YEAR
1992

MODEL
VIGOR

BULLETIN NO.
92-023

ABS Problem Code 1-8

BRACKET BOLTS

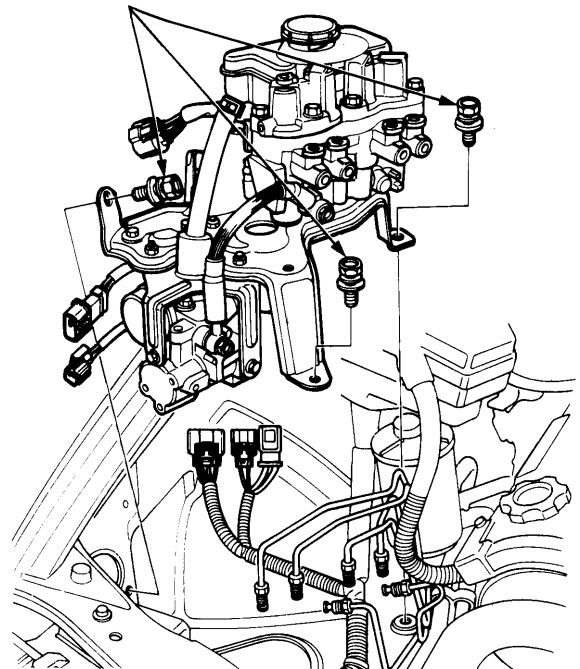
3. Remove the cruise control actuator mounting bolts, disconnect its connectors, and lay the actuator on the engine.
4. Disconnect the brake lines from the modulator.
5. Remove the three modulator bracket mounting bolts, then remove the modulator, power unit, and bracket as an assembly. Disconnect the modulator connectors during removal.

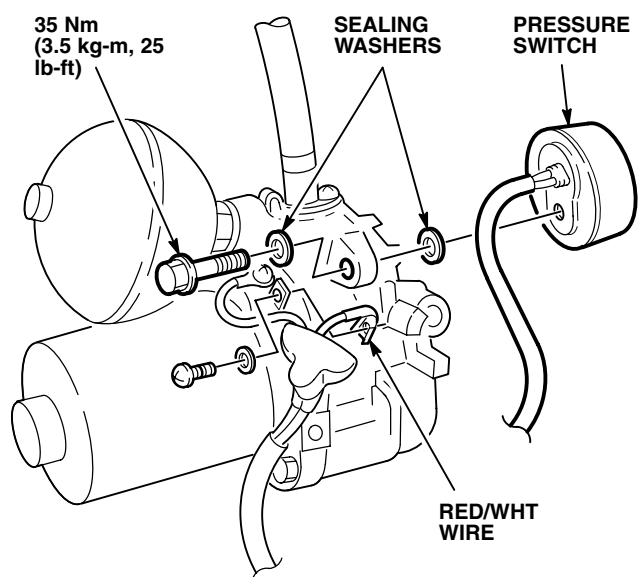
6. Remove the rubber cap covering the ABS pump wires, and disconnect the RED/WHT wire.

- Remove the original pressure switch, and install the new switch using new sealing washers (see PARTS INFORMATION).
